UNIVERSITY OF FLORIDA
TRAINING REACTOR
LICENSE NO. R-56
DOCKET NO. 50-83

SUBMITTAL OF RESPONSES DATED AUGUST 4, 2006, TO NRC REQUEST FOR ADDITIONAL INFORMATION FOR THE CONVERSION FROM HIGH-ENRICHED URANIUM TO LOW-ENRICHED URANIUM FUEL

Amendment 26
(previously Amendment 25)
UFTR Technical Specifications
Addendum 2

University of Florida Training Reactor, Facility License: R-56, Docket No. 50-83
Request for Change in Technical Specifications Approving HEU to LEU Conversion
With Responses to Requests for Additional Information

Figure 1 – Modified fuel assembly design by BWXT to include the "comb" design

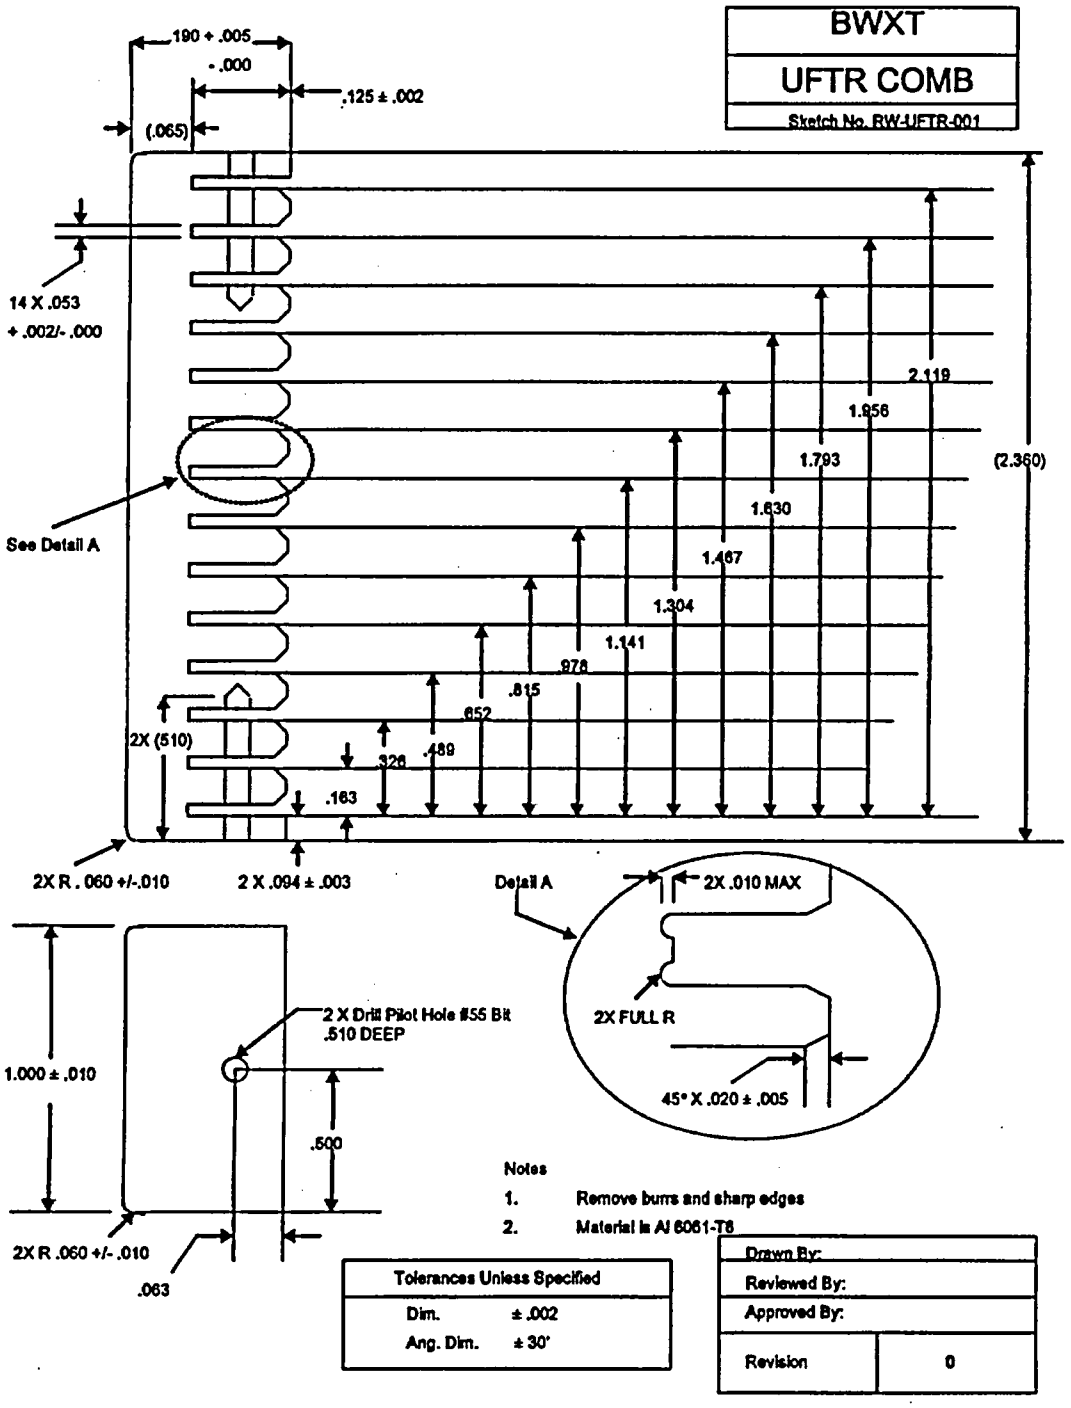
Initial inspection and measurement of LEU fuel assemblies manufactured by BWXT in July 2006 showed a variation in the water channel thickness that was larger than expected. In this design, the ends of the plates are separated by aluminum spacers and are bolted together. Aluminum spacers are welded onto the edges of the plates at about half their height. This fuel assembly design has been modified by BWXT to include the "comb" design shown in Figure 1 that will physically separate the fuel plates at the nominal quarter-points along the fuel plate length. In this modified design, the tolerance on the minimum water channel spacing is expected to be a maximum of ± 20 mils. The nominal water channel spacing at the bolted ends of the fuel assembly on the manufacturing drawings is 110 – 112 mils, giving a minimum water channel spacing of 90 mils.

The steady-state thermal hydraulic analysis described in Ref. 2 assumed hot channel factors based on a 1 mil tolerance for the water channel spacing, as shown on the manufacturing drawings at the bolted ends of the fuel assemblies. In the model, the ends of the fuel plates were assumed to be in contact with the fuel box wall. These new analyses account for two effects – the larger tolerance on the water channel spacing described above and the repositioning of the fuel assemblies in the fuel boxes due to the thickness of the combs extending beyond the edges

of the fuel plates. The combs introduce into the computer model another bypass channel pathway that is located between the fuel plate ends and the box wall. In these new analyses, the ends of the fuel plates are moved away from the wall of the fuel box by 0.065 inches - the height of the comb above the "teeth", as shown in Figure 1.

However, the newly created slot is actually blocked by the width of the comb (0.190 inches), at the quarter-points along the length of the assembly. There will be a small bypass flow through this pathway that is conservatively accounted for by including it as a clear channel, ignoring the blockage created by the presence of the combs. The pressure drop introduced by the combs is not accounted for because it is very small. As a result, the computed coolant flow through the heated channels will be reduced, and the ONB margin and other parameters will be conservative. The presence of the comb also reduces the width of the central channel slot between fuel assemblies. This is a significant beneficial change because it reduces the bypass flow through the central slot.

The actual minimum water channel spacing of each water channel in each finished fuel assembly will be measured by BWXT and made available by August 10, 2006. In case any one of the channel spacings is less than 90 mils, another comb will be added to maintain a minimum channel spacing of 90 mils.

Figure 3. True Power versus True Flow Rate at Which ONB Occurs with 10 mil Tolerance on Water Channel Spacing and Repositioning of Assemblies in Fuel Box to Account for Thickness of Combs.

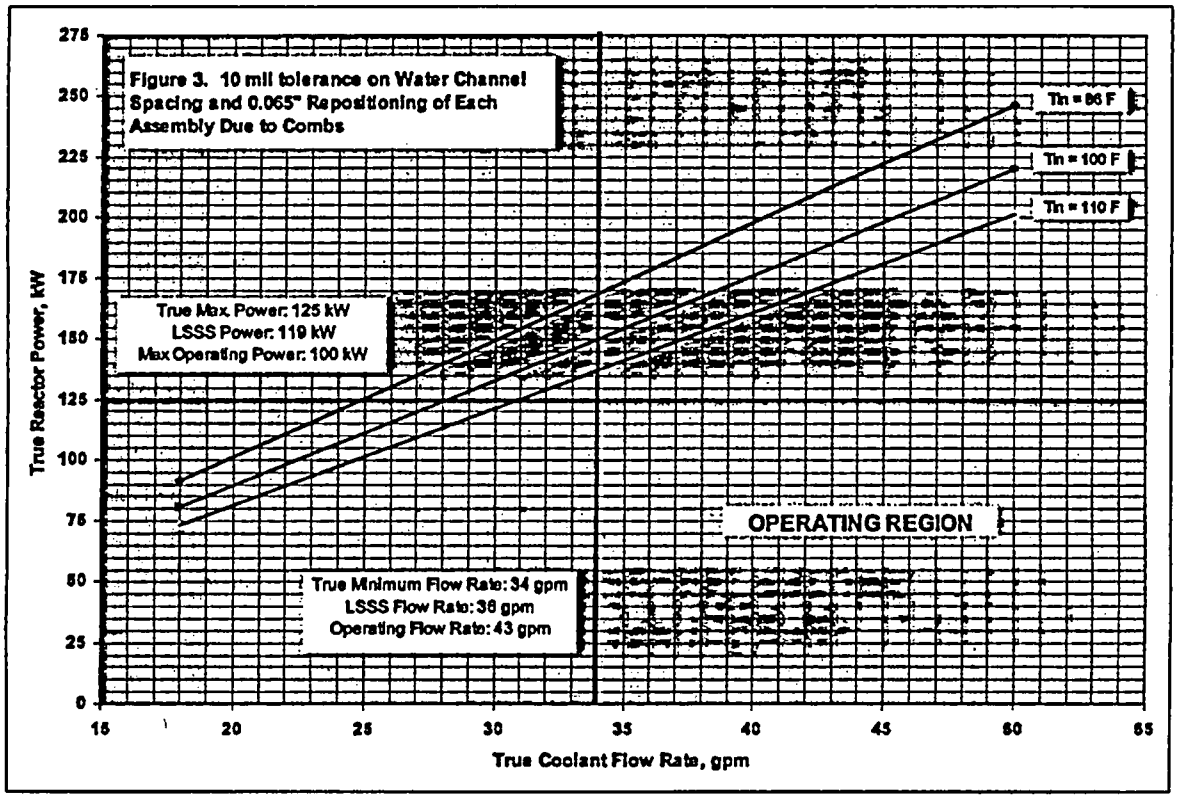
The new power versus coolant flow rate curves for water channel spacing tolerances of 10 mils, 15 mils, and 20 mils, along with repositioning of the fuel assemblies in the fuel box to account for the thickness of the combs are shown in Figures 3, 4, and 5, respectively.

a) If the maximum tolerance for the water channel spacing is 10 mil, we propose the following specifications:

Maximum T (inlet) = 110 F, and

Type of flow rate	Flow rate (gpm)
True Min. (gpm)	34
LSSS (gpm)	36
Operating (gpm)	43

Figure 5. True Power versus True Flow Rate at Which ONB Occurs with 20 mil Tolerance on Water Channel Spacing and Repositioning of Assemblies in Fuel Box to Account for Thickness of Combs.

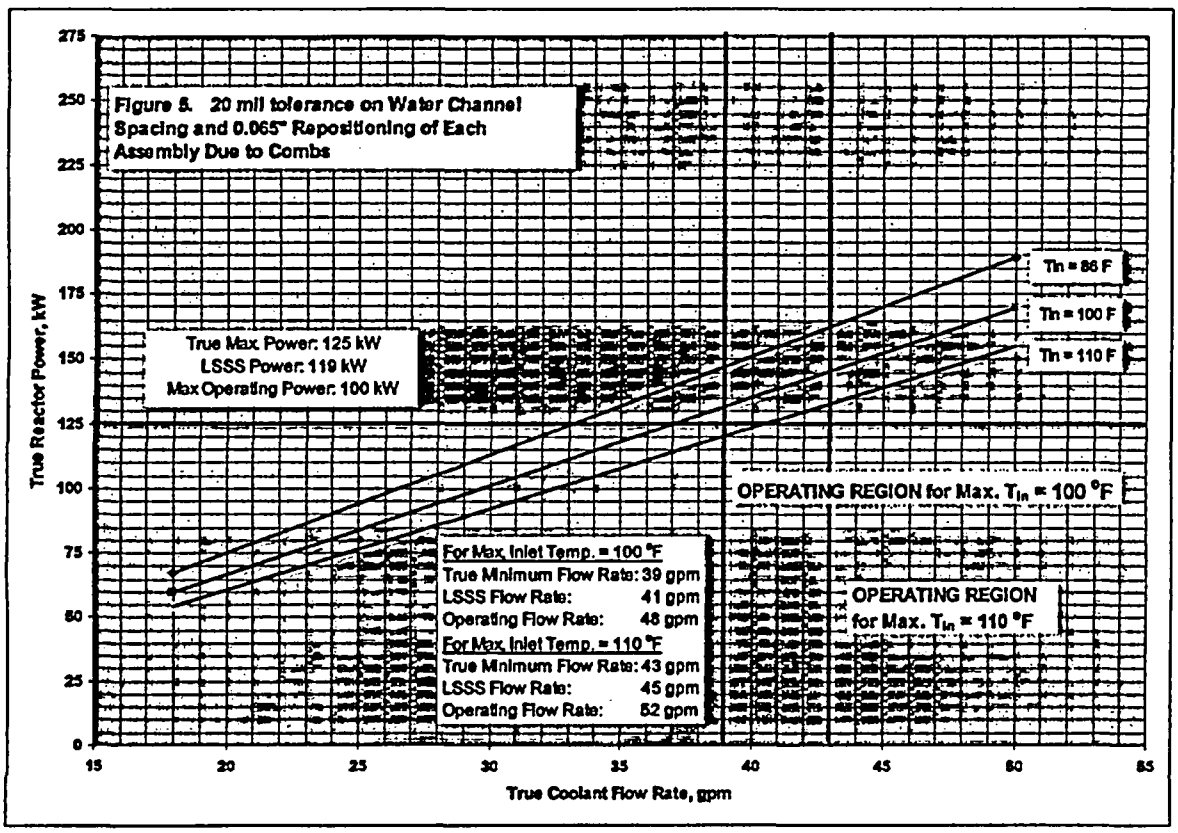
Since a measured minimum water channel spacing of 90 mils (20 mil tolerance) is anticipated on a number of the LEU fuel assemblies being re-worked by BWXT, the following values for key coolant flow rate parameters are proposed in Table 5. The UFTR Technical Specifications will need to be changed.

c) If the maximum tolerance for the water channel spacing is 20 mil, we propose the following specifications:

Maximum T (inlet) = 100 F, and

Type of flow rate	Flow rate (gpm)
True Min. (gpm)	39
LSSS (gpm)	41
Operating (gpm)	48

Figure 4-16 Integral Blade Worth versus Position for Safety 3 in the UFTR HEU Core.

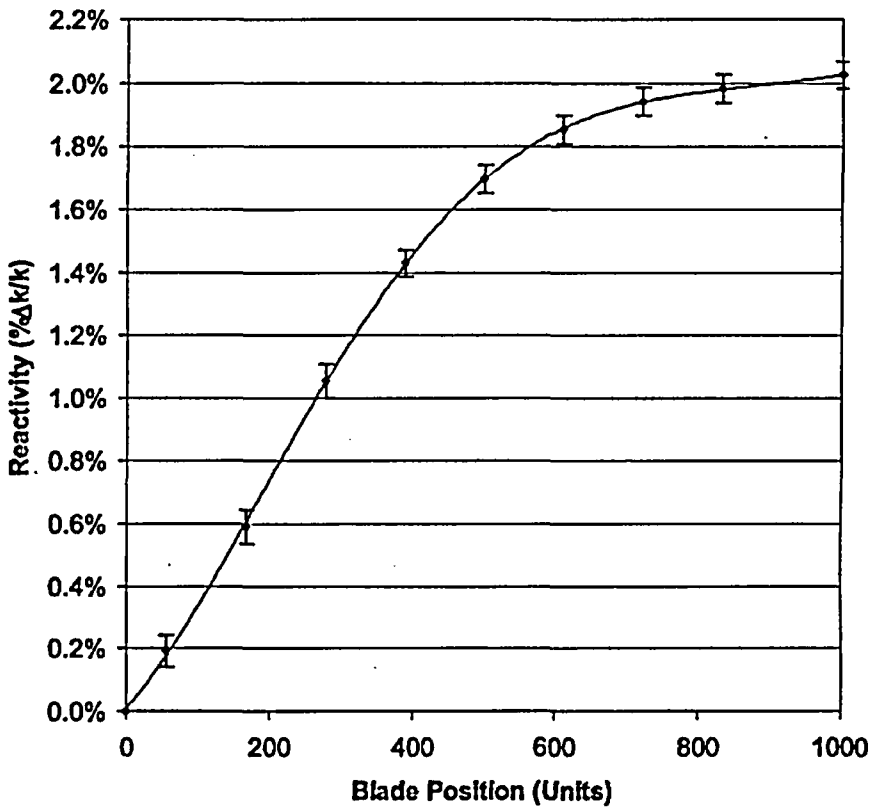
B.2 Changes to page 29 of the December's Submittal

Figure 4-16 shows calculated the Safety Blade 3 (most reactive blade for HEU core) worth as a function of position.

The UFTR Technical Specifications require that the reactivity insertion rate from control blade withdrawal must be less than 0.06% Δk/k/s when averaged over a 10 second interval. The rate of reactivity insertion resulting from withdrawal of the highest worth blade was approximated by assuming a 100 second (minimum allowed) blade withdrawal time. As shown in Table 4-14, the highest rate of reactivity insertion from withdrawal of Safety Blade 3 is 0.042% Δk/k/s, which meets the requisite UFTR Technical Specification.
